Subject: Draft Environmental Impact Statement (DEIS) for the Silicon Valley Rapid Transit Corridor (SVRTC) BART Extension to Milpitas, San Jose and Santa Clara, Alameda and Santa Clara Counties, California (CEQ #040134)

EPA DETAILED COMMENTS ON THE DRAFT ENVIRONMENTAL IMPACT STATEMENT (DEIS) FOR THE SILICON VALLEY RAPID TRANSIT CORRIDOR (SVRTC) BART EXTENSION, May 21, 2004

RESPONSE TO COMMENT LETTER R7

R5.3

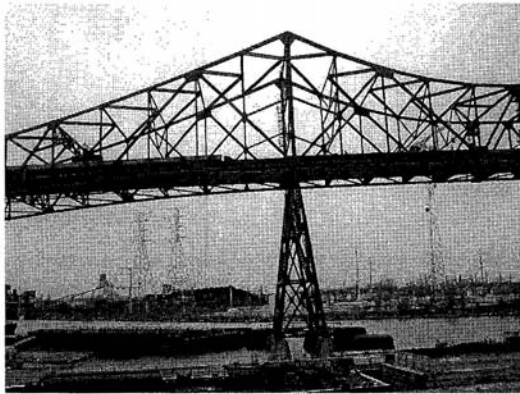
With regards to the underground pedestrian connection, concern has been expressed about pedestrian safety. However, a recent visit to Alexandria Virginia has shown that with modern technology and building techniques this is not a reasonable concern. They have constructed an underground crossing to link the new King Street MARC transit

facility to the existing historic RR station and have experienced no problems with this crossing by incorporating several visual and technological schemes into its design.

R5.3 *The comment is noted and included in the record for consideration by the decision-makers.*

Chicago, Illinois RR Bridge

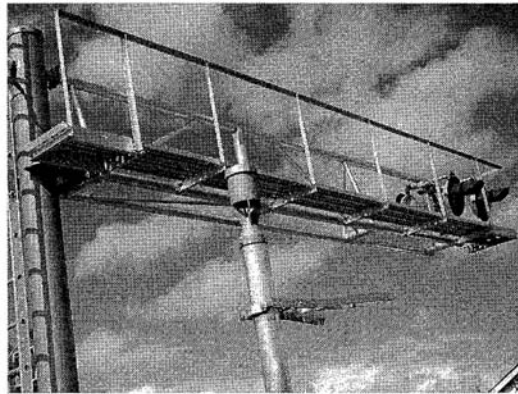
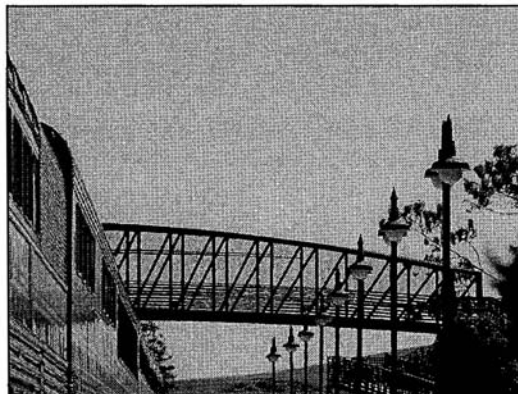
p.4.17-32, Santa Clara Station and Pedestrian Crossing – We fully agree with the statement that “ Architectural sensitivity in the design of the BART station, pedestrian walkway, and parking facilities would be important because of the proximity and historical nature of the Santa Clara Caltrain station, Train Control Tower, and related facilities.” Especially important would be the architectural design of the BART station and any aerial walkway. We would recommend that design elements incorporate and be compatible with the design elements of railroad structures in order to lessen their impact.

For example, San Luis Obispo has an aerial walkway over the tracks in close proximity to its historic depot. This design compliments the railroad line and depot by utilizing components found in RR overcrossings.

R5.4 *The comment provides suggestions for the architectural design and treatment of the historic Santa Clara Caltrain Station and pedestrian overcrossing. VTA will continue to work with the SBHRS on developing an effective MOA or PA that will include Design Standards and Guidelines to minimize impacts.*
